SERVICE INFORMATION NO. SI 42NG-012

AE Mandatory Service Bulletin MSB-E4-007
ATA-Code: 72-40

MANDATORY SERVICE BULLETIN

Replacement of Waste Gate Controller

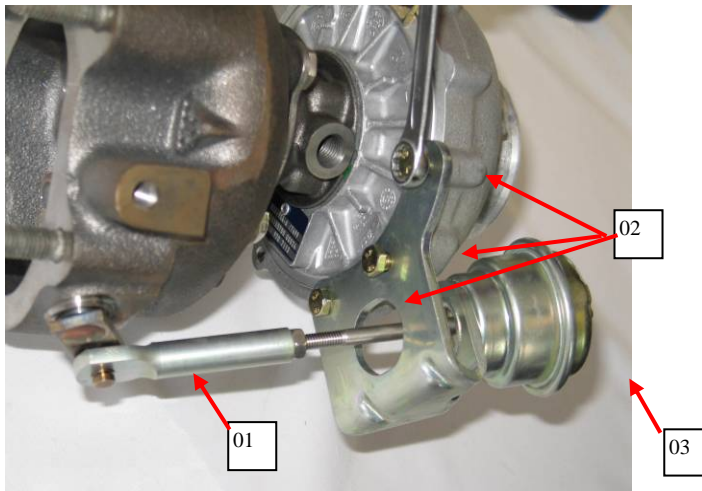
1. Disconnect Hose at the top of the Waste Gate Controller
2. Remove three M6 Bolts [02]
3. Remove Circlip [01]
4. Disconnect rod from waste gate lever and remove waste gate controller [03]

1. Install the three M6 Bolts [02] and torque them with 7 Nm
2. Attach external pump to the top of the Waste Gate Controller and apply pressure till the rod starts to move
3. Connect rod to waste gate lever
4. Adjust Waste Gate Controller according to Engine Maintenance Manual E4.08.04, Chapter 81-00-32.

Note: For fixing of the rod on the waste gate lever use new circlip.
